Re: Response to Planning Comments - File Review for Project No. 13-20-0158 / Township of Langley

BC BUILDS - ALDERGROVE

FRASER HWY & 272
STREET, LANGLEY BC

sheet no. A1.00

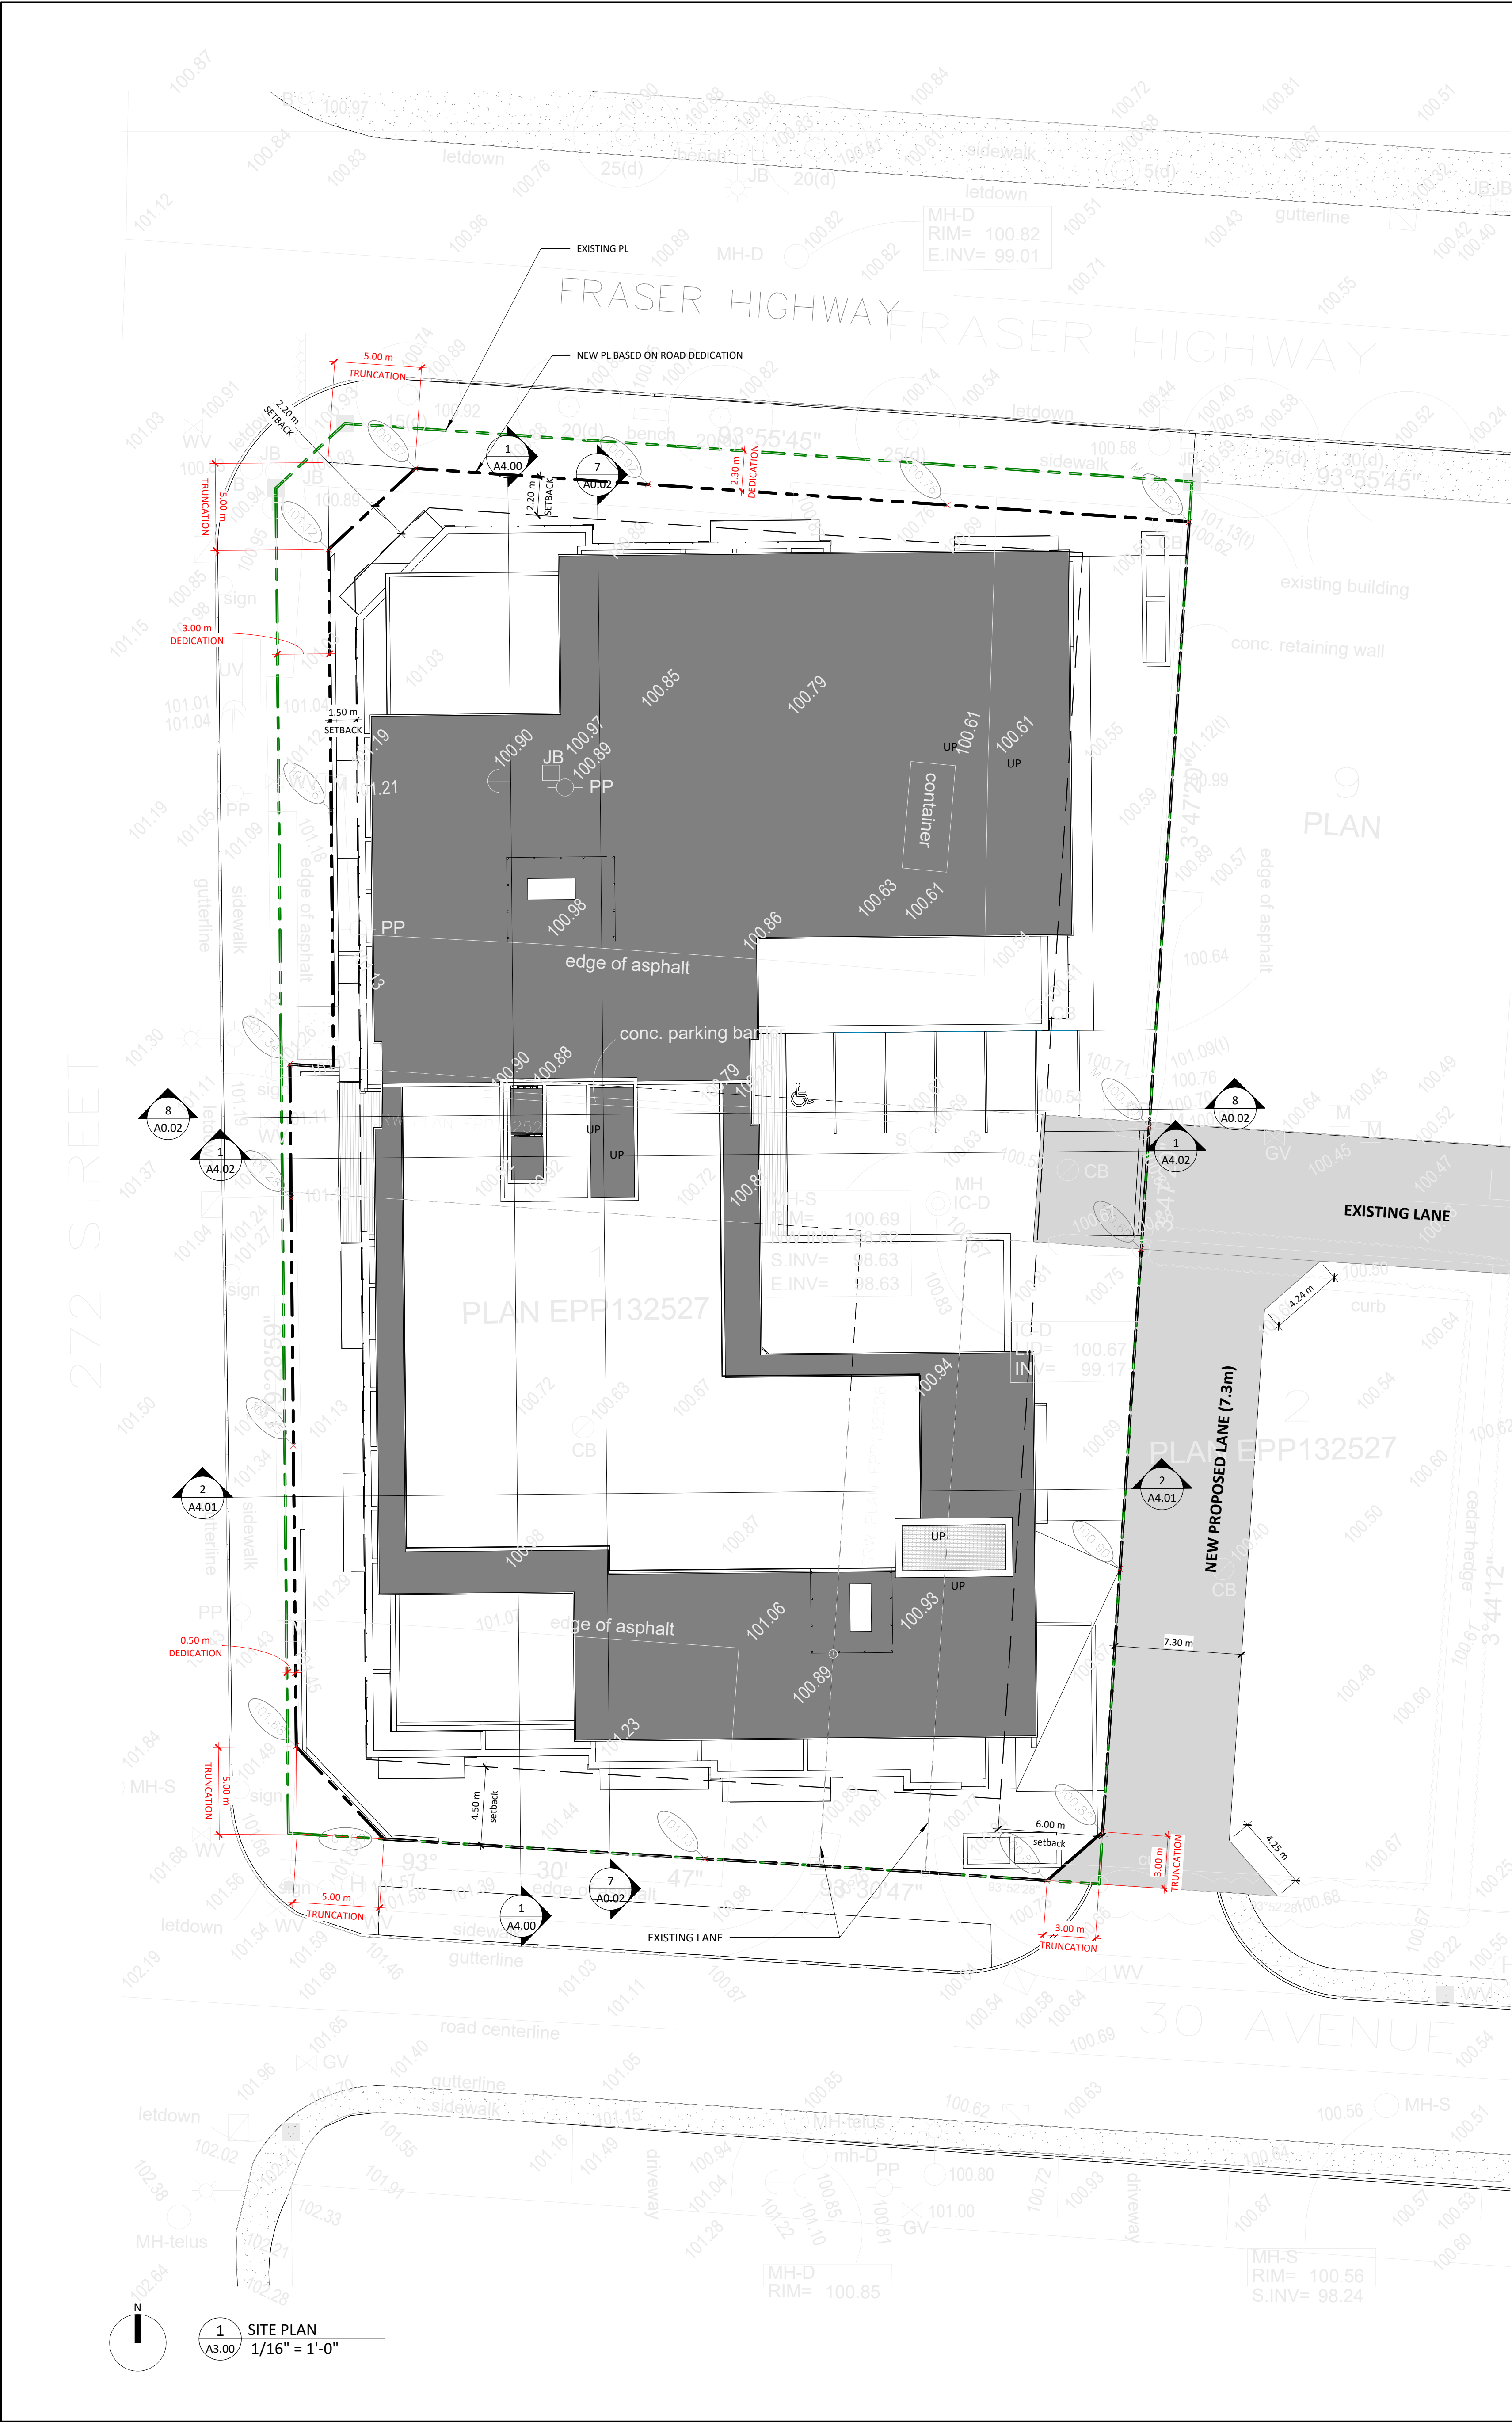
3. Section 105.6 permits a maximum of small car spaces for visitor and commercial spaces. Accordingly, please revise your proposal to reflect:
 - a. a maximum of 20% of total permitted visitor stalls as small car spaces
 - b. a maximum of 20% of total required commercial parking spaces

- **Small car parking count has been revised to reflect the requirements. Please see revised calculation on sheet A1.00 and revised plans on A1.01, A1.02, and A1.03.**

REVISED SMALL CAR COUNT
